## Product Change Notification - SYST-08UUHO160

ERRATA - dsPIC33CH128MP508 Family Silicon Errata and Datasheet Clarification

## dsPIC33CH128MP508 Family Silicon Errata and Data Sheet Clarification

FIGURE 1: I/O RAMP

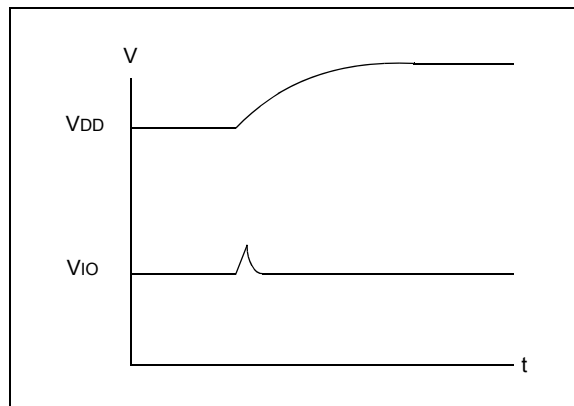
During a fast device power-up, when the V<sub>DD</sub> ramp is less than 4 mS, the I/O pins may drive up to 100  $\mu$ A current for a duration of up to 10  $\mu$ S (Figure 1).

1. Slow down the V<sub>DD</sub> ramp time (greater than 4 mS for V<sub>DD</sub> to ramp 0V to 3.3V).
2. Ensure the circuitry that is connected to the pins can endure this pulse.

Example applications affected may include complementary power switches, where a transient current shoot-through might occur.

High-voltage applications with complementary switches should power the high-voltage 200  $\mu$ Sec later than powering the dsPIC<sup>®</sup> device to avoid the current shoot-through. This behavior is specific to each device and not affected by aging.
